# Siding Inspection

**Orion Home Improvements**  
 8404 Harland Dr.  
 Springfield, VA 22152  
 Phone (703) 926-9824  
[Jdavis.roofing@gmail.com](mailto:Jdavis.roofing@gmail.com)

**ANY ITEM MARKED "NO" WILL BE SIGHTED WITH PHOTOGRAPHS ON THE FOLLOWING PAGES AND REFERENCED TO THE VINYL SIDING INSTITUTE INSTALLATION GUIDE (VSIIG) version 2007 ASTM 4756 standard**

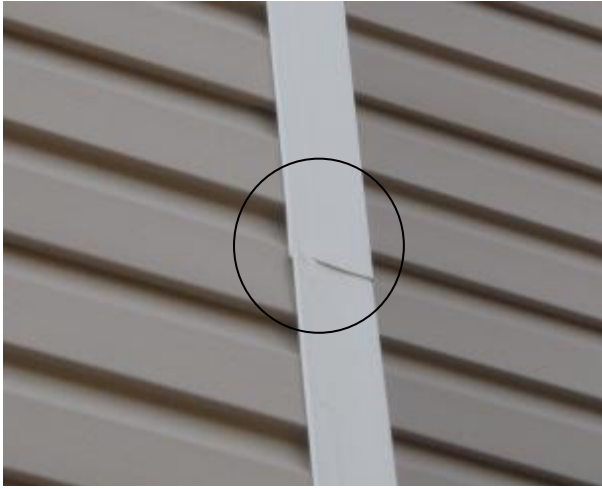
1. Siding buckled in appearance on front wall in these locations

2. Starter strip not fastened properly at test location 23" OC. VSIIG Pg 19. Requires 10" OC

3. All J channel on home is missing Rain tabs and not sealed. VSIIG Pg 21 requires rain tabs

3. J channel does not have 1/2" clearance off shingles and there is no kickout flashing at the bottom termination. Excessive silicone installed with poor functionality and appearance. VSIIG Pg. 23 requires 1/2" gap Pg 25 requires kickout flashing.

4. No undersill or utility trim is used to hold cut siding tight at top edge terminations. No snap lock lugs installed into siding panel. VSIIG Pg. 24, 25 requires undersill trim and snap lock lugs

5. Outside corner post is NOT FASTENED AT ALL at this test location. VSIIG Pg. 18 requires 8 to 10 inch OC fastening of accessories.

5. Outside corners improperly lapped at seams. VSIIG Pg. 18 requires  $\frac{3}{4}$ " overlap with 1" nailing flange cut away to avoid buckling.

6. Siding panel not locked into starter strip.

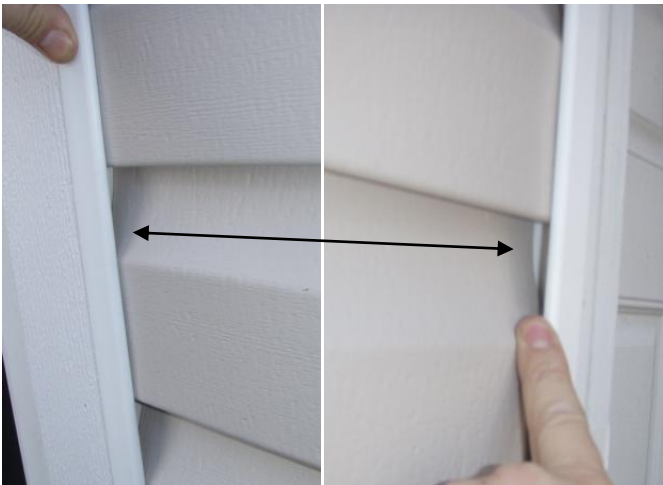
7. Nails used in the installation of the siding are of the correct style and size for vinyl siding application, however the nails are not spaced properly at multiple inspection points. Positioning in several locations was such that the siding would bind on the nail slot.

8. Siding cut too short for proper seat into the corner post. Adjustment not possible without opening overlap seam at other end. VSIIG Pg 23 requires  $\frac{1}{4}$ " clearance and 1" overlap

8. Both ends of this panel are tight against the pocket of the trim accessories not allowing for expansion and contraction of siding. VSIIG Pg. 23 requires  $\frac{1}{4}$ " clearance

9. The courses at this inside corner are an example of not being aligned properly.

11/ 12. Soffit panels not properly secured and loose lay on top of siding receiver J channel. It does not have its own dedicated soffit F channel along the rear wall.

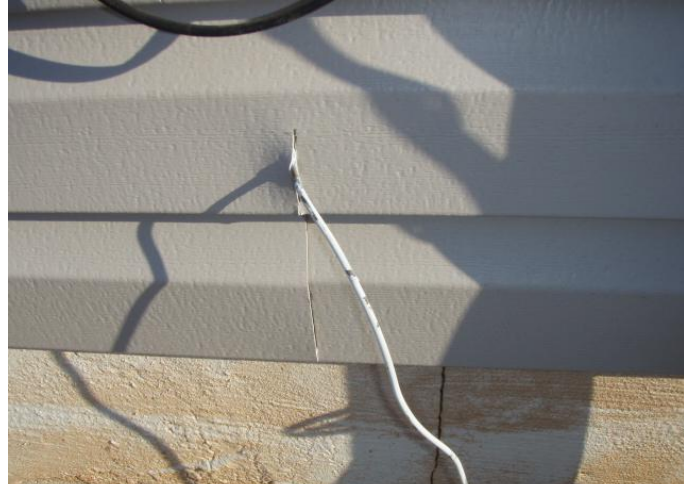
14. Siding is cut straight up leaving open to the elements. VSIIG Pg. 24 requires a new panel of siding be installed at the protrusion to allow for a proper seam.

14. Siding cut too wide around this penetration. VSIIG Pg. 24 requires 1/4" gap around penetration with cut to follow contour of the penetration.

14. Existing vent trimmed out with J channel very poor installation will allow water behind siding.

15. Siding not properly cut to fit around gable vent. New panel on each side of bottom edge with short cut scrap double seamed into the wall.

16. Custom aluminum trim capping around garage door is poorly installed, no stiffening breaks formed allows for oil canning with improper termination.
